Access Compliance Report Public Rights-of-Way (Curb Ramps)

Main Street: SILVERWOOD_DR Cross Street: FOSTER_RD Location: N

ADA ID: RPAT211202115721 Ramp Type: Type 1 - Perpendicular Diagonal Initial Pass/Fail: Fail Overall Compliance: No Severity Score: 15

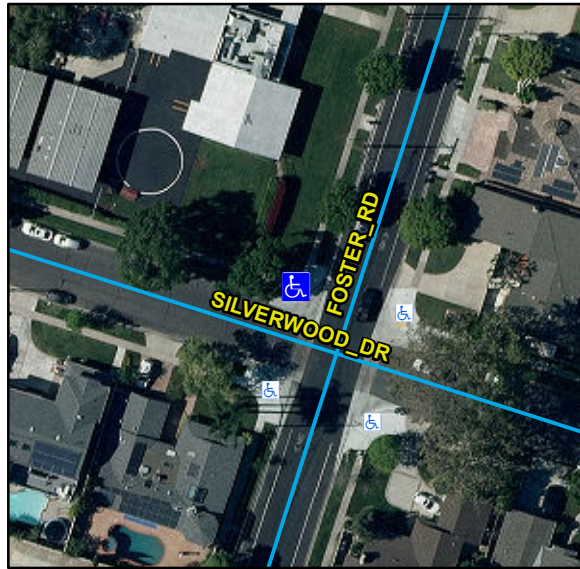
Compliance	Description	Data	Compliance	Description	Data
N/A	Ramp Length (in)	84	N/A	Flare Type LT	
Yes	Ramp Width (in)	48			N/A
No	Ramp Run Slope (%)	8.8	N/A	Flare Slope LT (%)	N/A
Yes	Ramp Cross Slope (%)	1.5	N/A	Flare Traversable LT	N/A
N/A	Landing Present	N/A	N/A	Flare Type RT	
N/A	Landing Length (in)	N/A			N/A
N/A	Landing Width (in)	N/A	N/A	Flare Slope RT (%)	N/A
N/A	Landing Run Slope (%)	N/A	N/A	Flare Traversable RT	N/A
N/A	Landing Cross Slope (%)	N/A	N/A	DWS Provided	N/A
N/A	Landing Movement Obstructed?	N/A	N/A	DWS Contrast	N/A
	Landing Movement Type	N/A	N/A	DWS Length (in)	N/A
N/A	Landing Shared	N/A	N/A	DWS Full Width	N/A
N/A	Clear Space	Yes	N/A	DWS Offset Left (in)	N/A
N/A	Clear Space To Crosswalk (in)	N/A	N/A	DWS Offset Right (in)	N/A
N/A	Marked Crosswalk 1	Yes	N/A	Marked Crosswalk 2	No
	Crossing 1 Direction	SW		Crossing 2 Direction	SE
	Marked Crosswalk 1 Width (in)	120		Marked Crosswalk 2 Width (in)	N/A

Remove & Replace Curb Ramp With Two New Directional Ramps or Equivalent.

R304.2.2, STD 1115
